Bayside Local Planning Panel - Other Applications will be held in the Committee Room, Botany Town Hall Corner of Edward Street and Botany Road, Botany on Tuesday 8 July 2025 at 5.00 PM

- 6 REPORTS DEVELOPMENT APPLICATIONS
 - 6.1 MDA-2024/201 30-34 High Street Mascot Section 4.56 Modification..2

Application No MDA-2024/201

Modification to DA-2021/463 including an increase to the height and floor area of the building, conversion of four 2-bedroom units into 3-bedroom units, changes to external

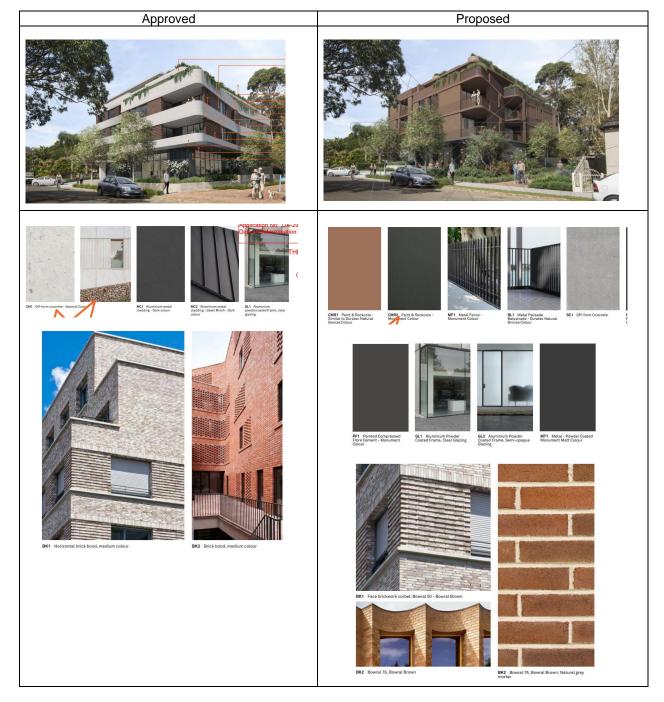
The proposal as modified seeks to alter previously approved material and finishes of the development, including replacing concrete spandrels and balustrades with corbeled face brickwork and introducing metal palisade balustrading in lieu of entirely concrete balustrades. A comparison is provided below.

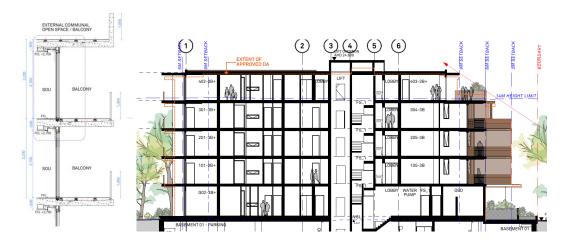
A maximum height standard of 14m applies to the subject site. A comparison of building height between the approved and proposed schemes is provided below.

Height	Approved	Proposed	Difference	Complies
14m	17.375m top of lift overrun 3.375m (24.1%) variation	18.225m top life overrun (30.2%) variation	+0.85m	No – Refer to discussion below.

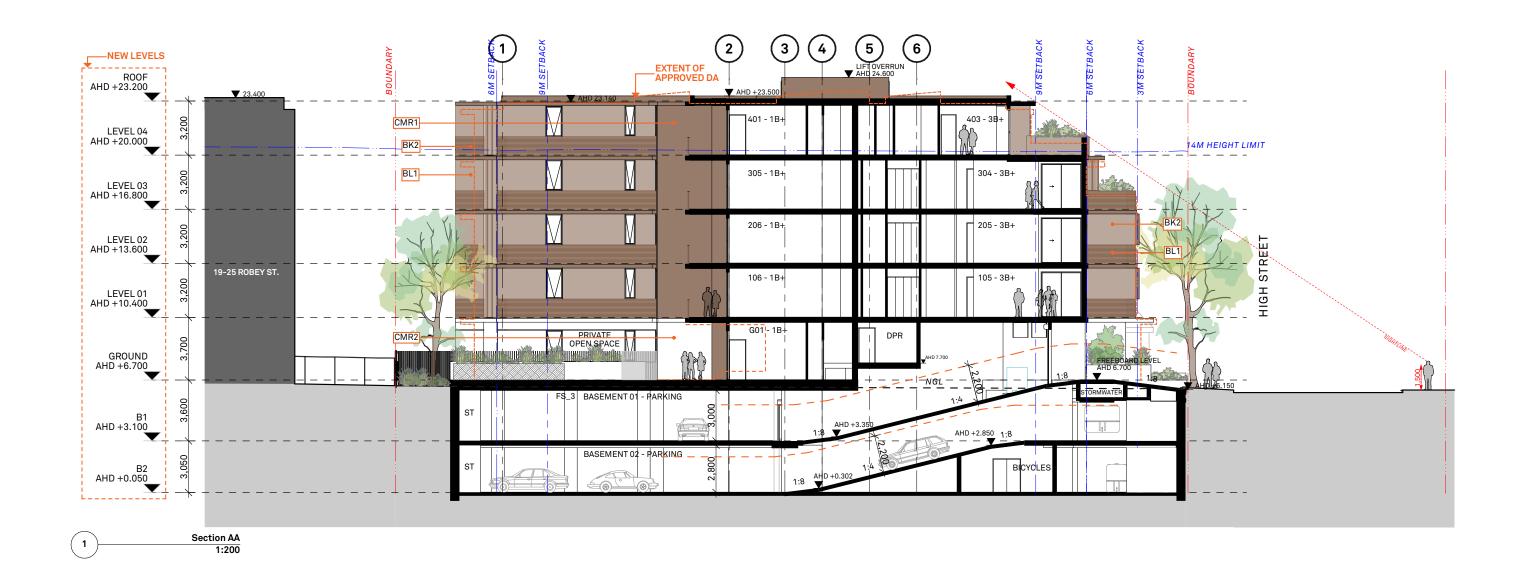
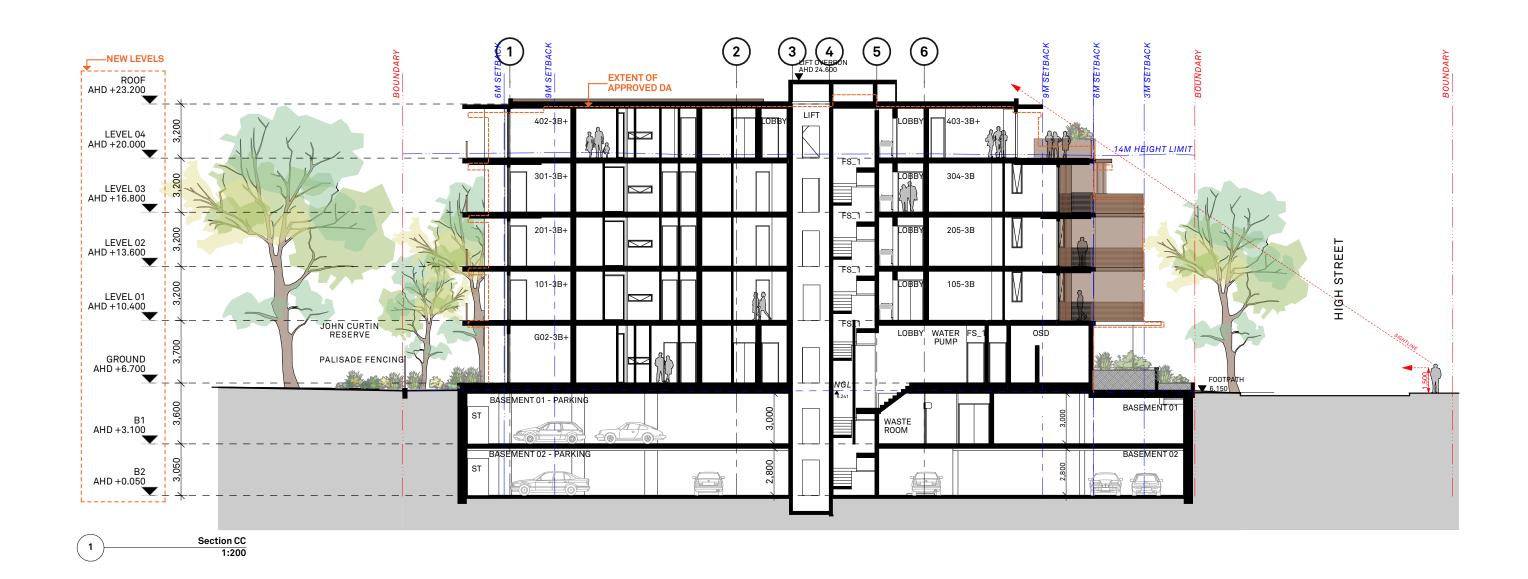
Amend Section to:- Accommodate internal chnages such as relocation of egress passages and removal of pedestrian access to and from John Curtin Reserve.

REVISION 17:
- Move the western glass-line of the Apartment No.G03 by 300mm toward the site boundary.

Amend Section to:- Accommodate internal chnages such as relocation of egress passages and removal of pedestrian access to and from John Curtin Reserve.
